AERONAUTICAL CHARTING FORUM
Instrument Procedures Group
October 21-22, 2002
HISTORY RECORD

FAA Control # 02-02-246

Subject: Turn Angle Limits for RNAV Approaches without TAA's

RNAV (GPS) RWY 17 ORLANDO INTL (MCO)

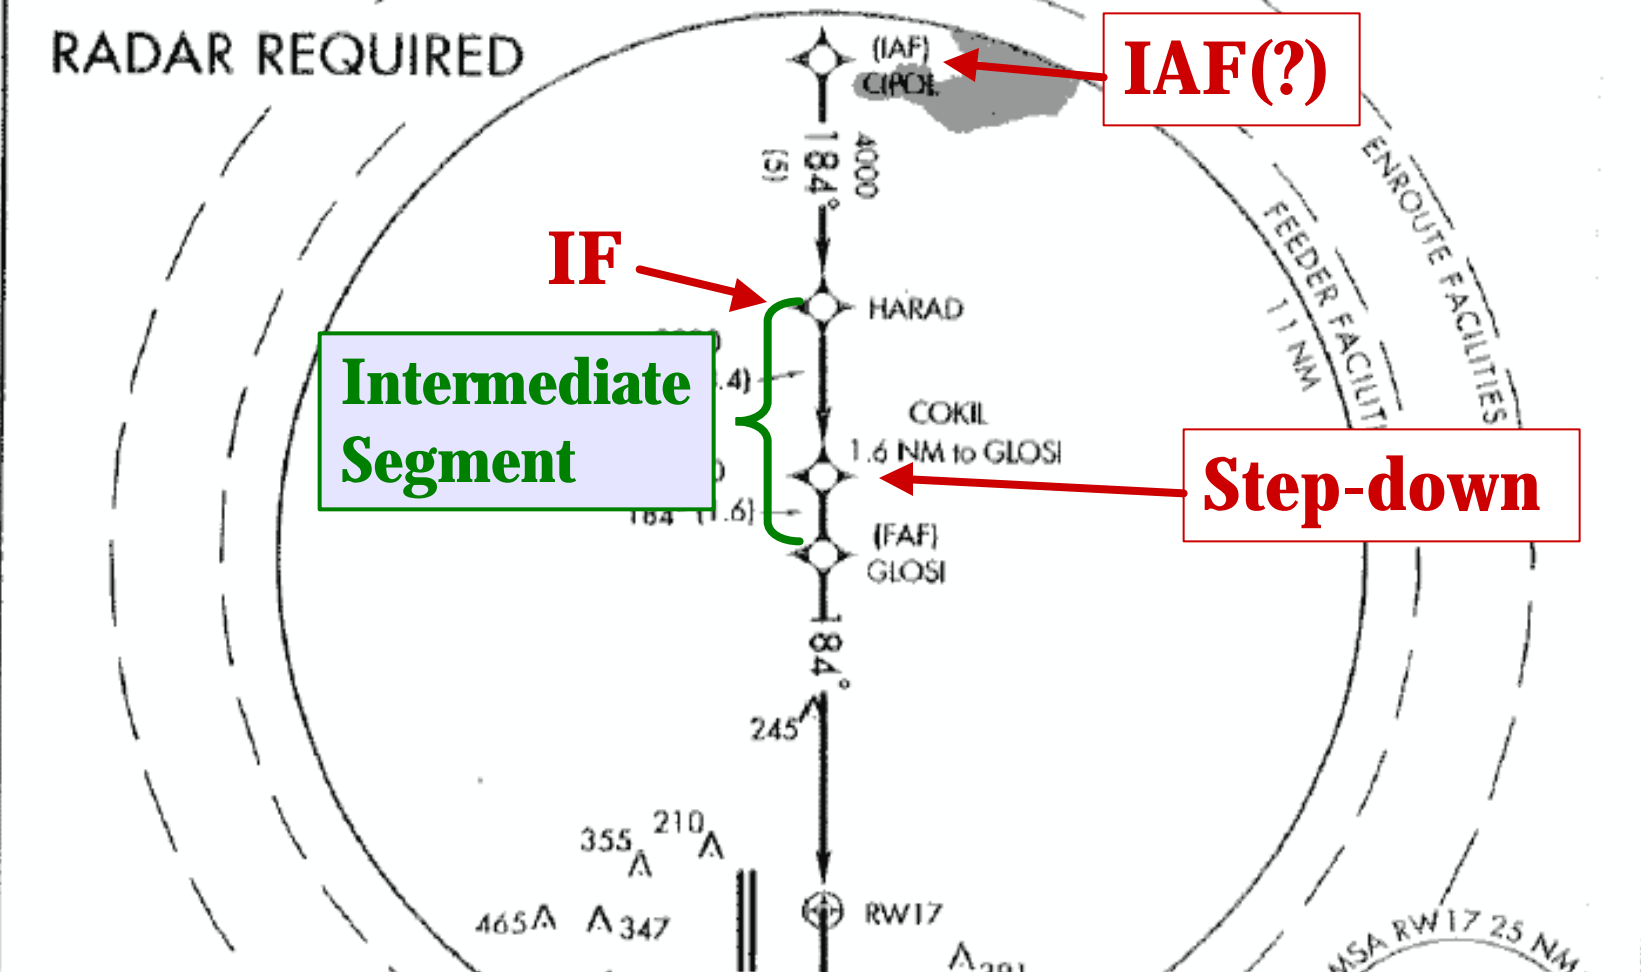
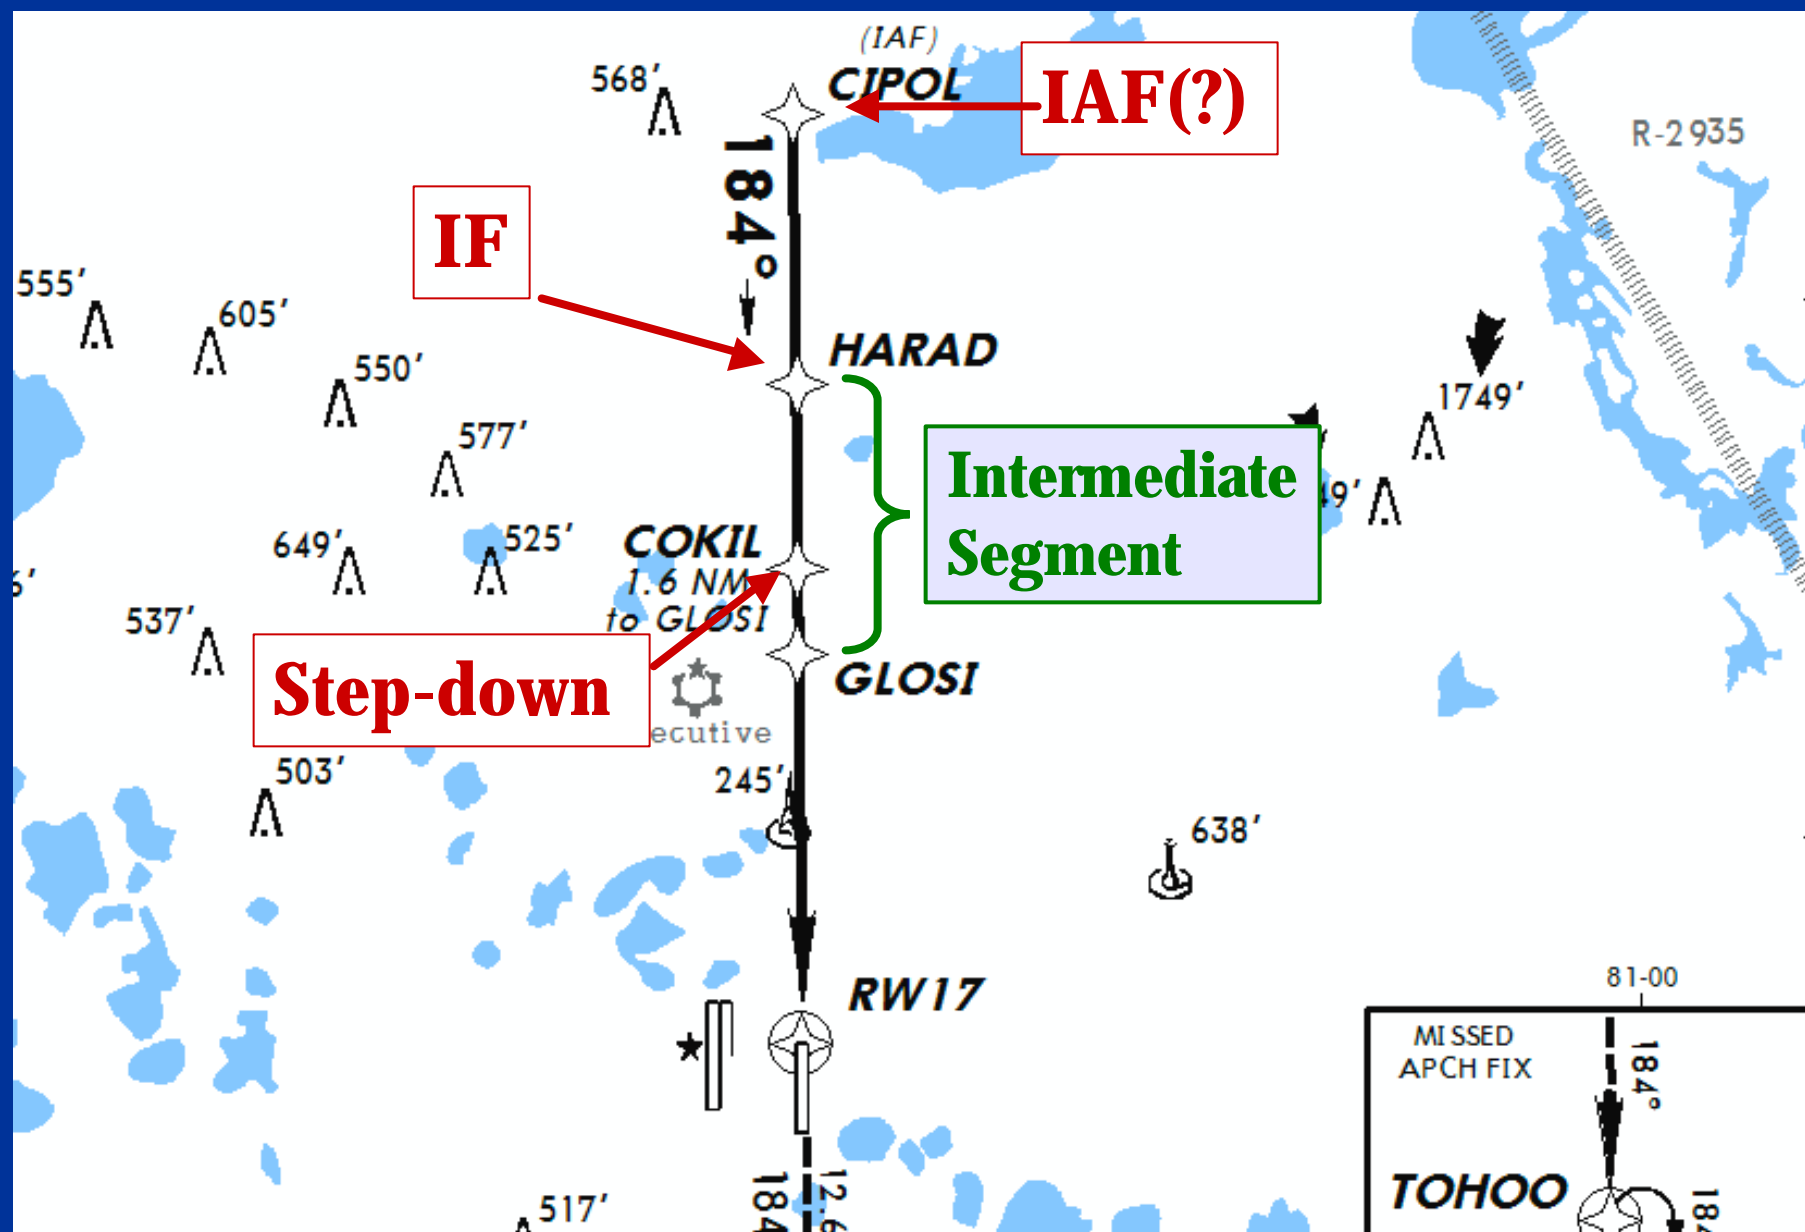
IAF(?)

RNAV (GPS) RWY 17L DALLAS-FORT WORTH INTL (DFW)

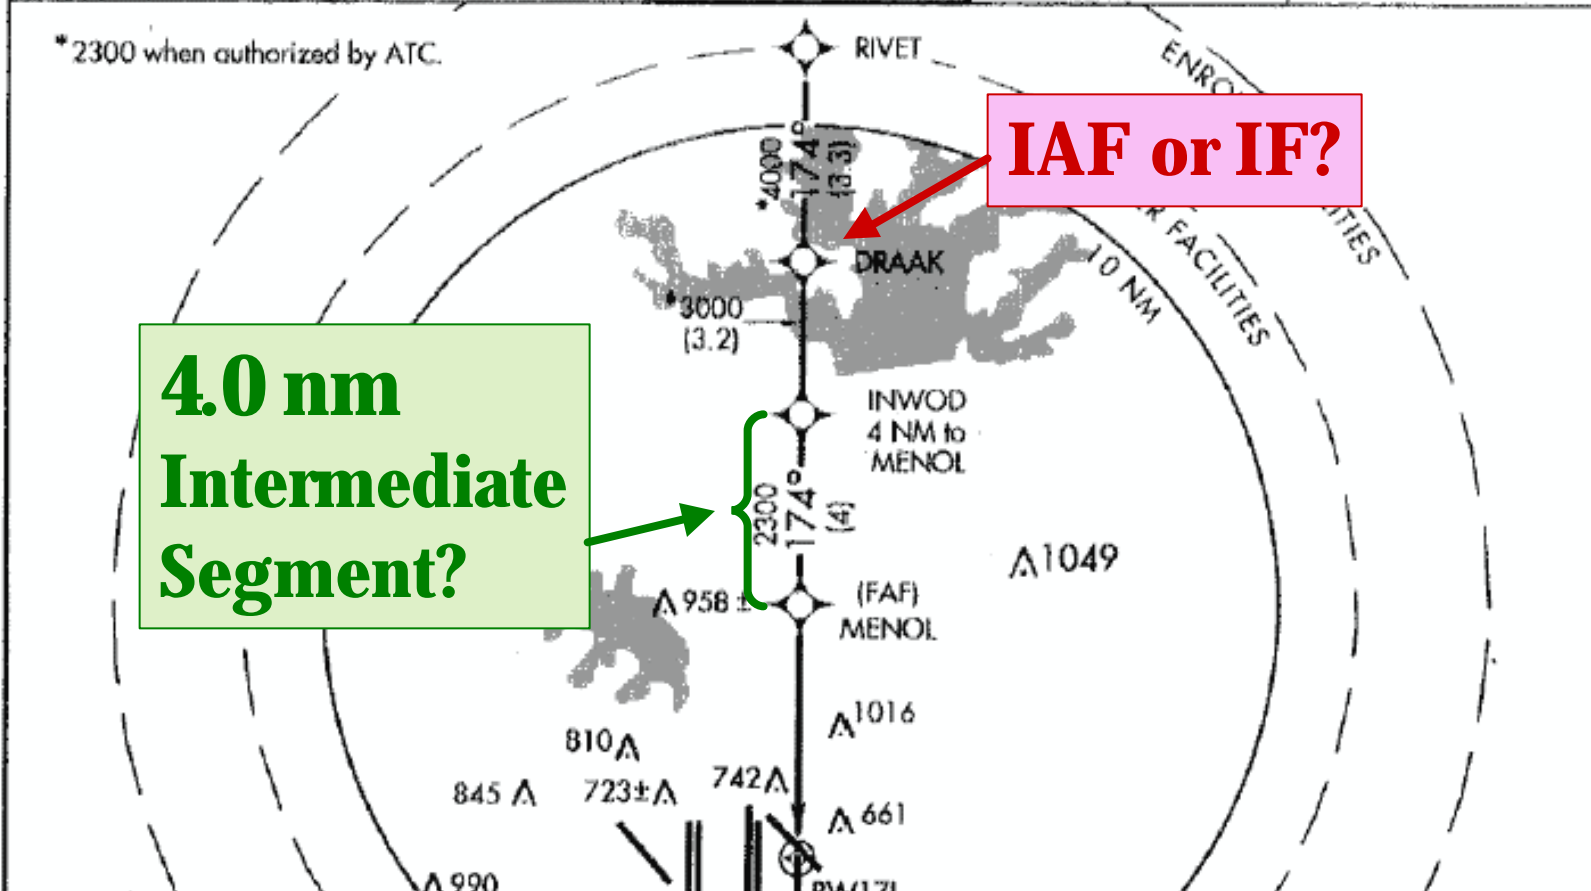
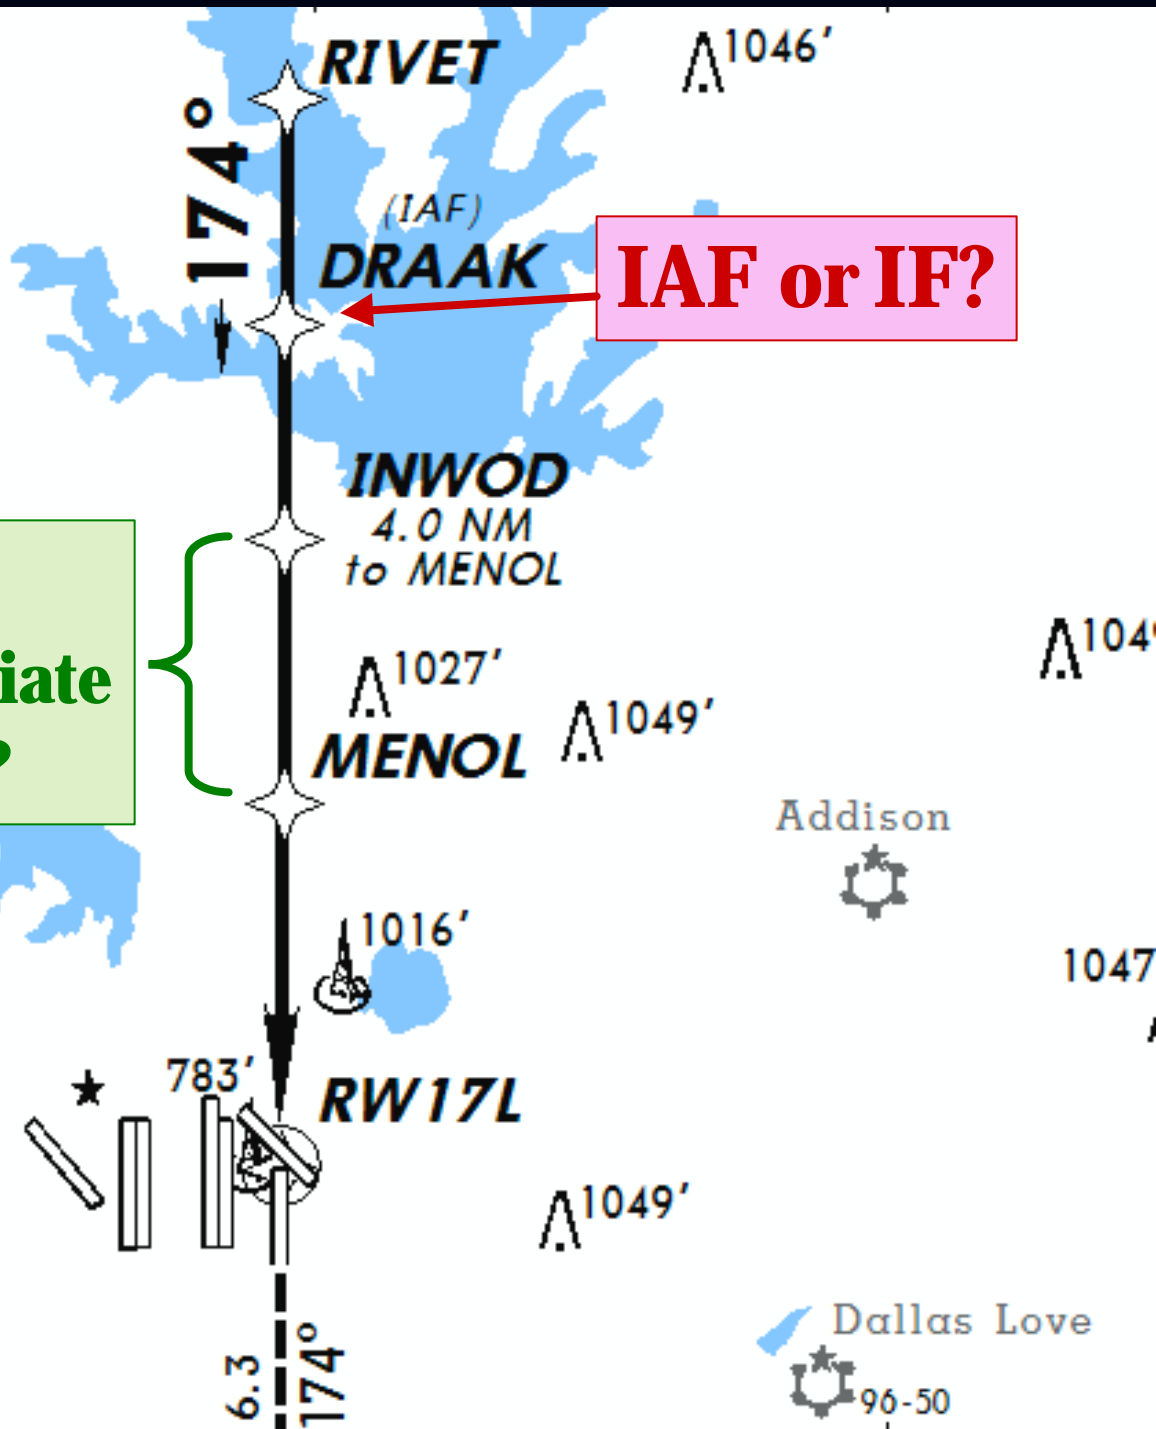
**4.0 nm
Intermediate
Segment?**

IAF or IF?

**4.0 nm
Intermediate
Segment?**
